HDC

ADMINISTRATIVE APPROVALS

March 04, 2020

FLOOR PLAN

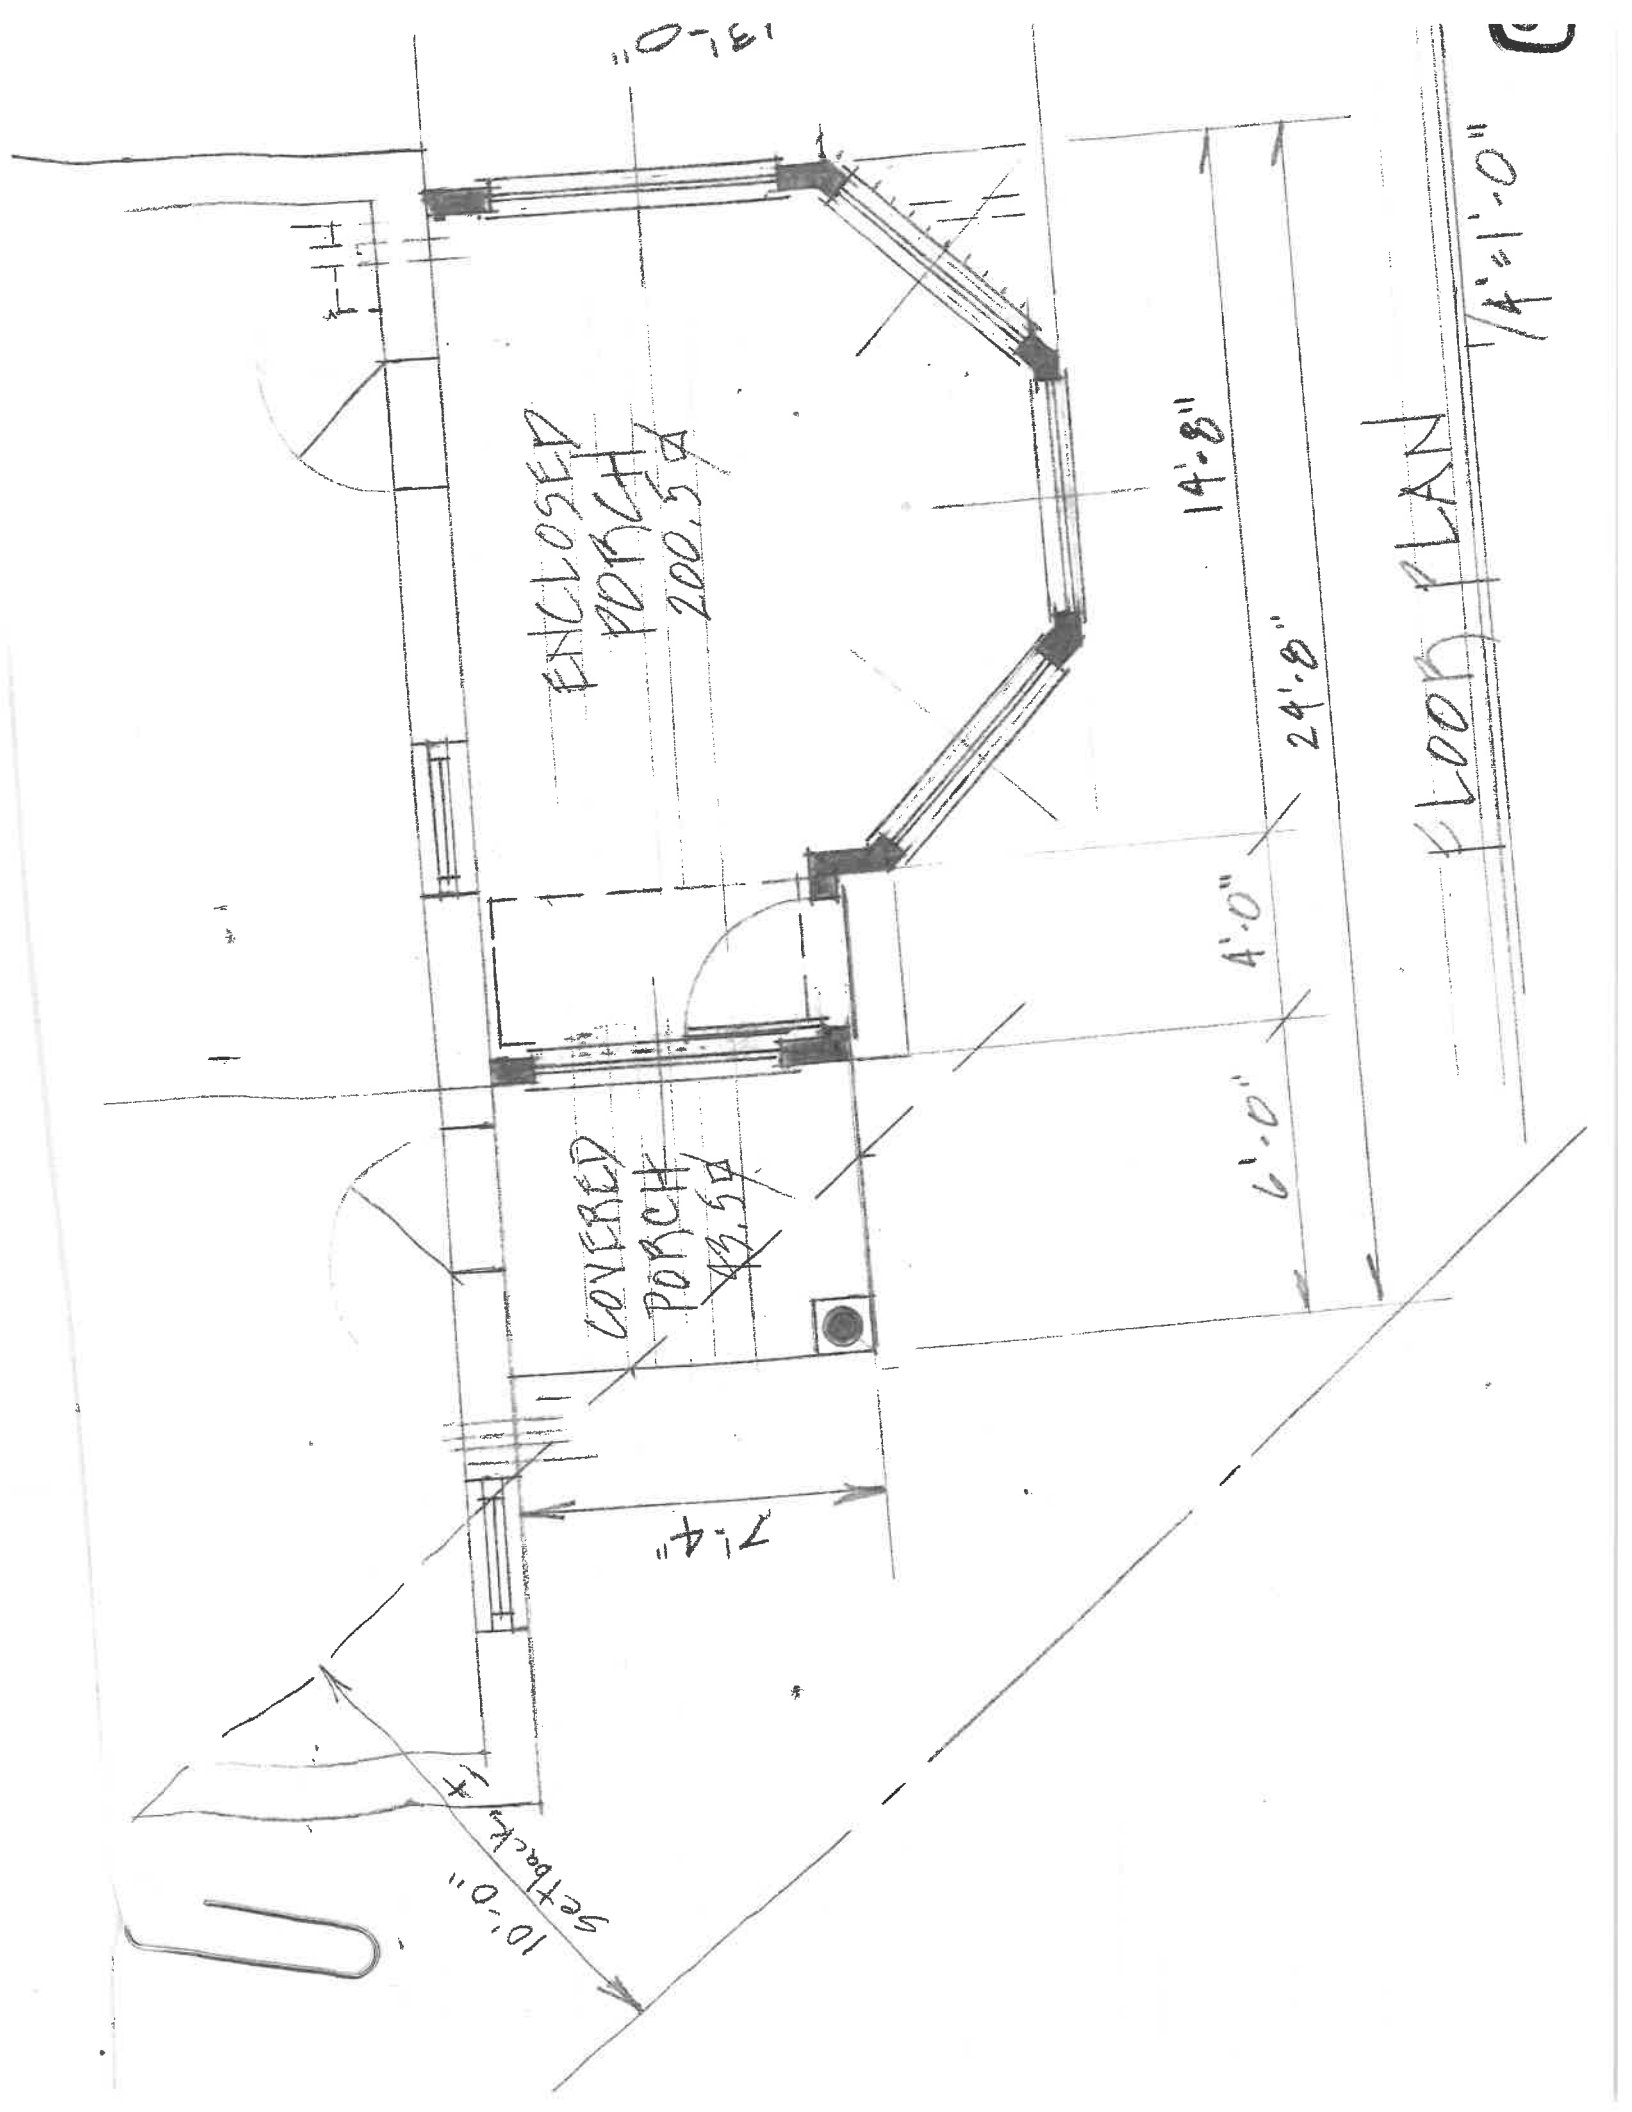
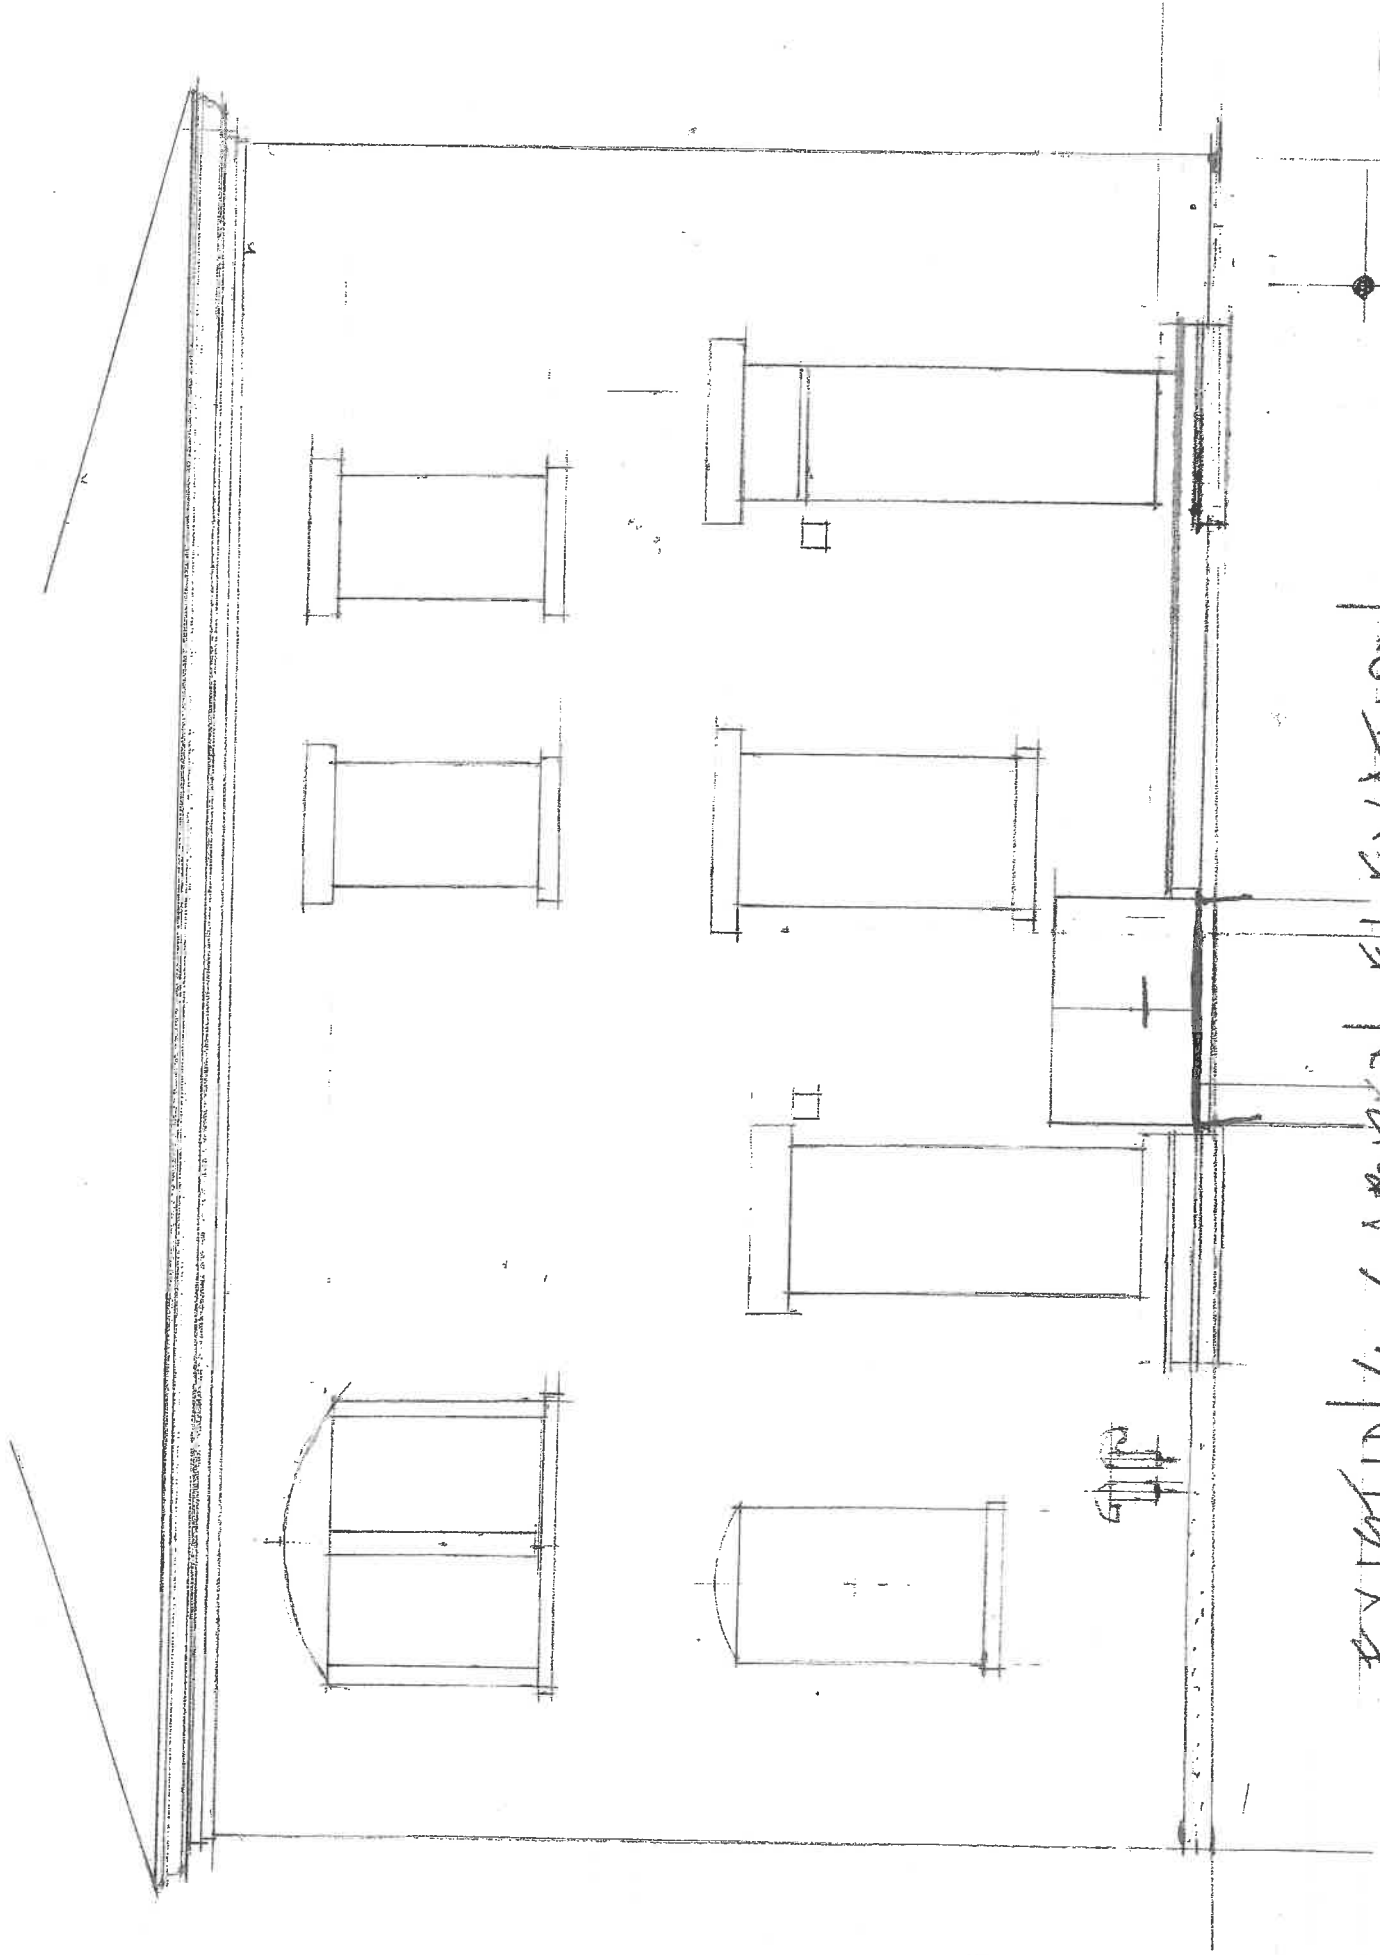
Background: The applicant is seeking approval to construct a new enclosed porch.

Staff Comment: Recommended Approval

SHEET NUMBER A1	PLAN NUMBER 1079	JASON BREWSTER 121 MECHANIC STREET PORTSMOUTH, NH 03801	DATE	DESCRIPTION	NEWMARKET PLAINS, LLC. HOME DESIGN SERVICE NEWMARKETPLAINSLLC@COMCAST.NET WWW.NEWMARKETPLAINSLLC.COM 603-659-0385	REGISTERED ARCHITECT A1 B.D. ARCHITECTURE

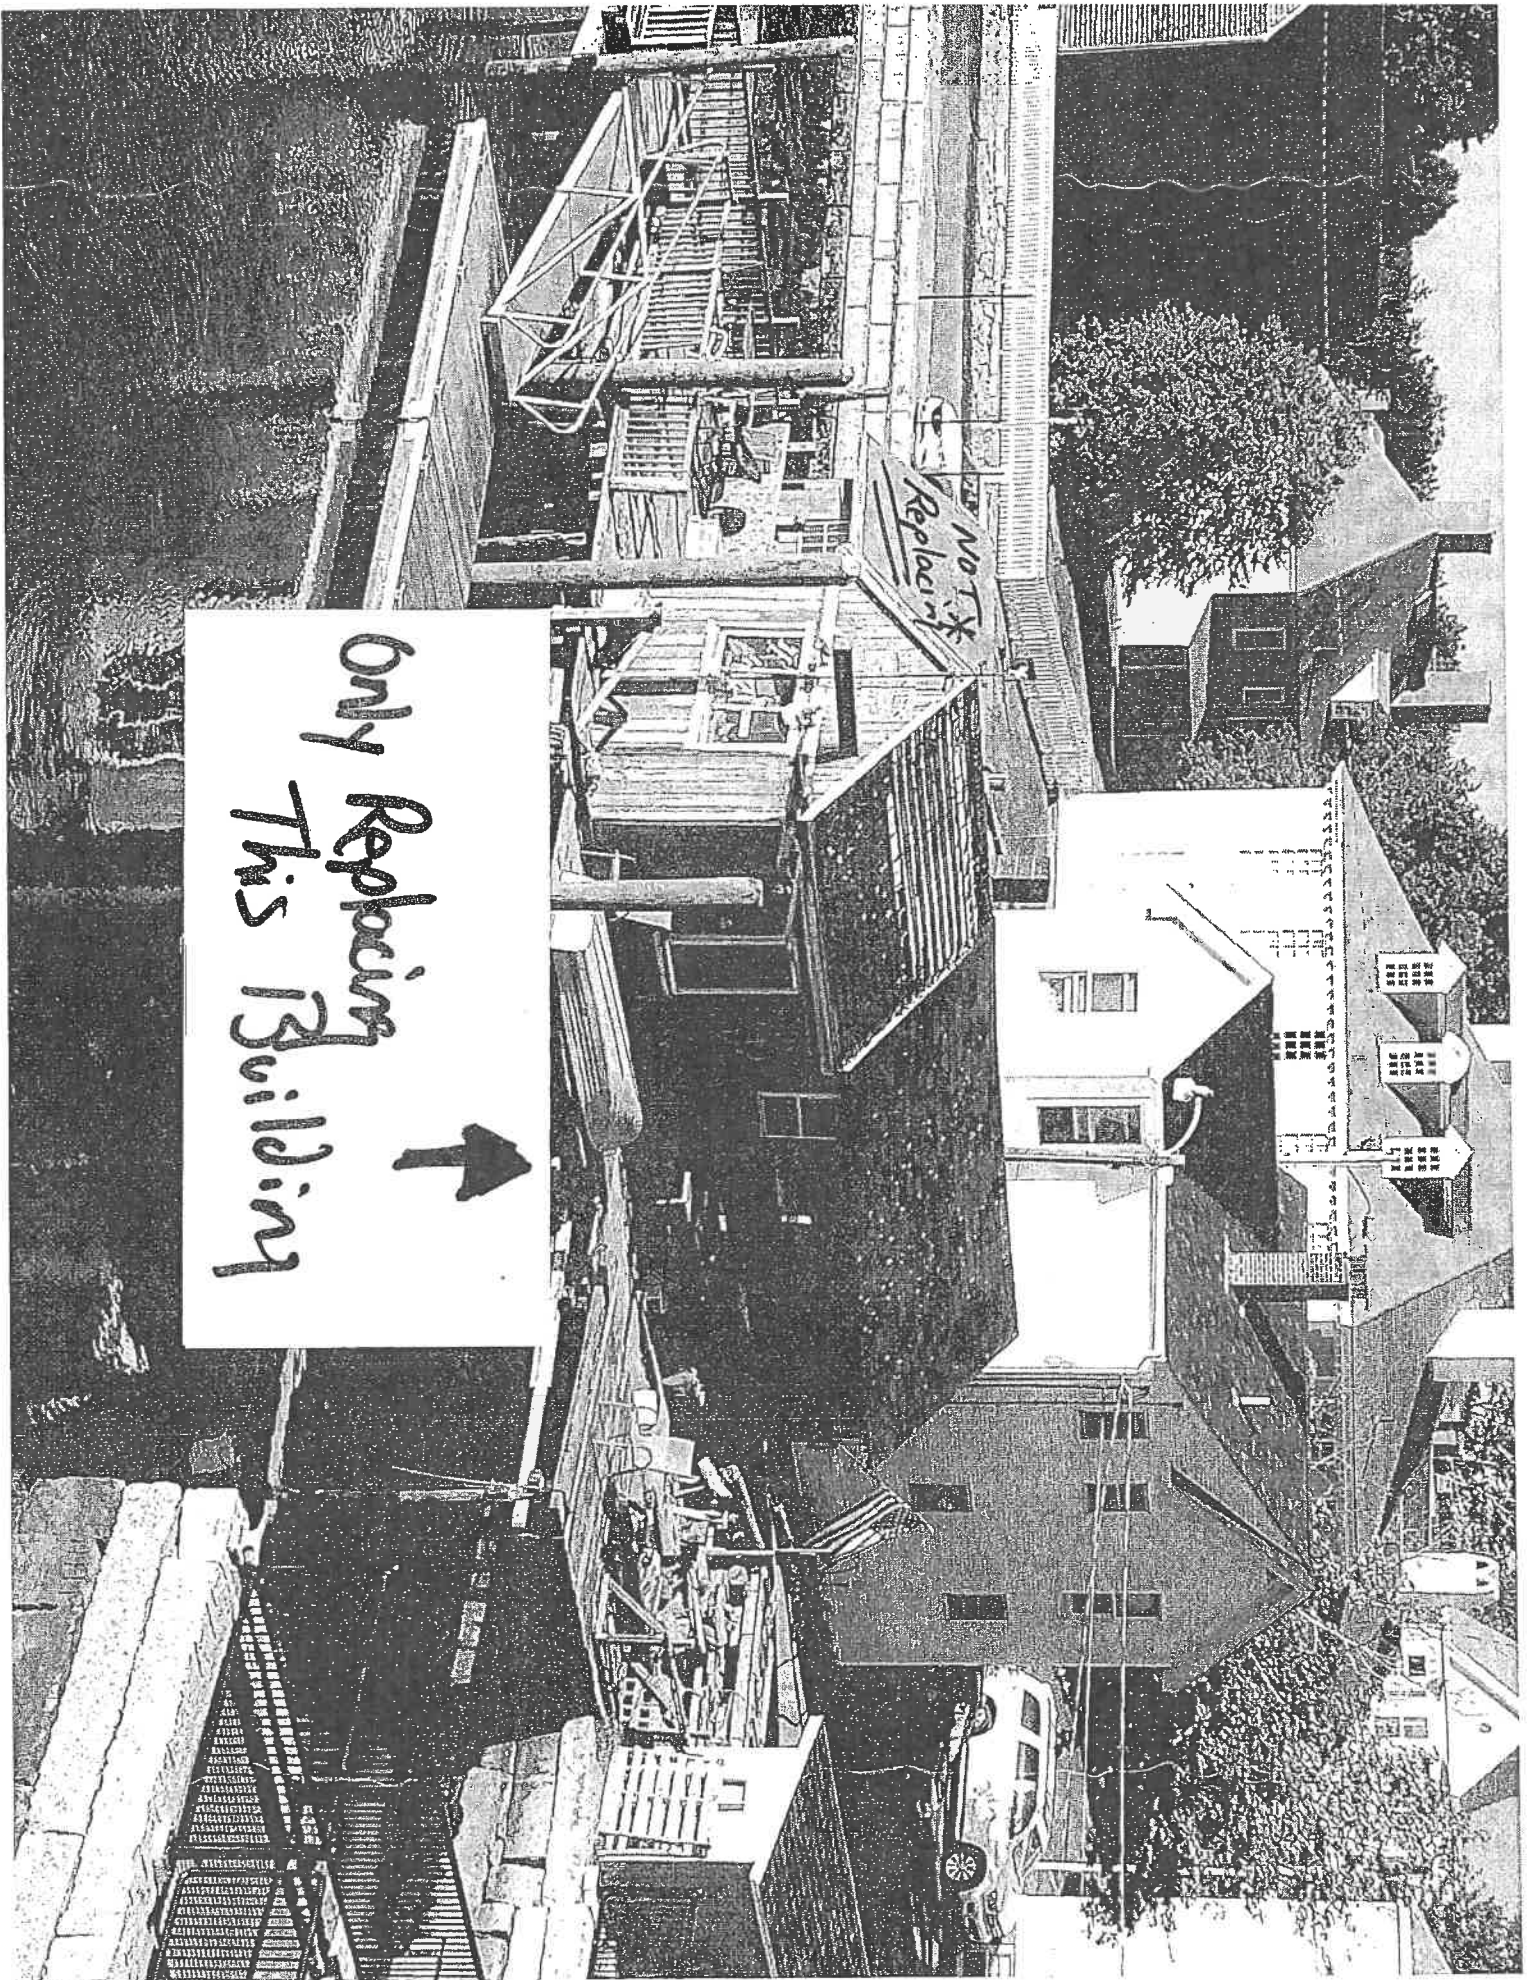
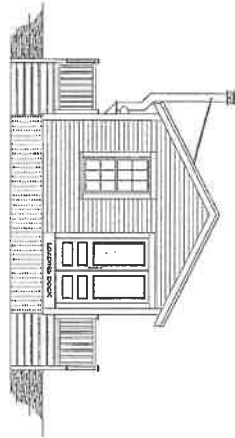
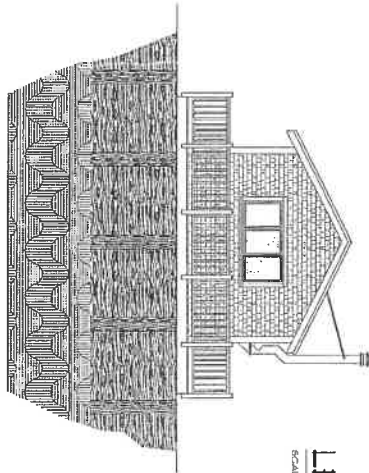
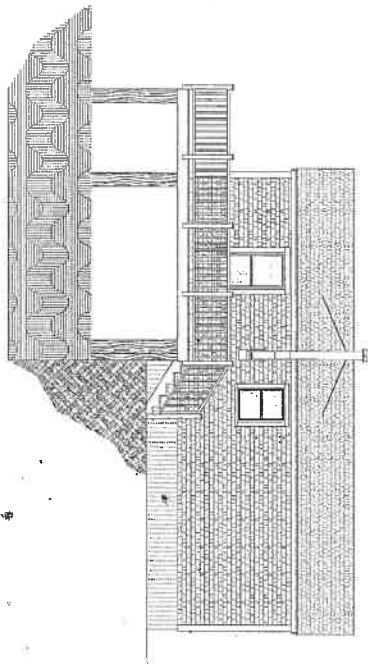
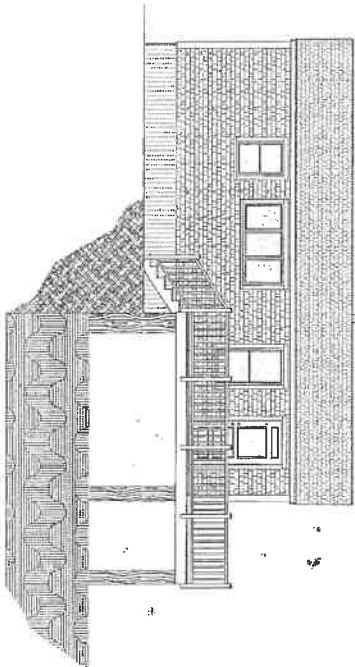
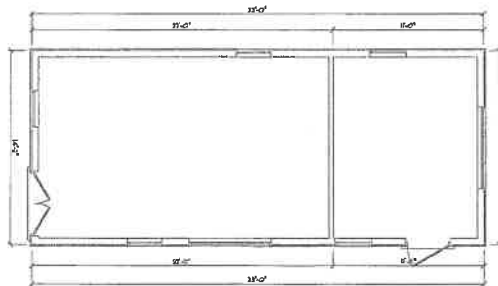
Background: The applicant is seeking approval to replace in-kind only one (1) one of two previous accessory buildings on the site. The reconstructed building will retain original dimensions, location, and configuration.

Only Replacing
This Building

Staff Comment: Recommended Approval

Front Elevation, replace 2 exist. Velux Skylights, same size & location

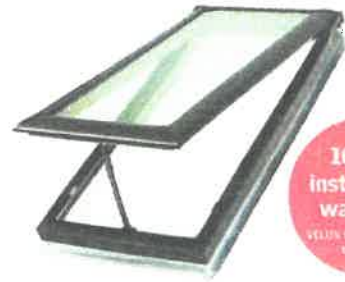
Rear Elevation, replace 2 exist. Velux Skylights, same size & location

Replace Main House Roofing to Match Rear Additon,
Architectural Onyx Black Asphalt Shingles.

Staff Comment: Recommended Approval
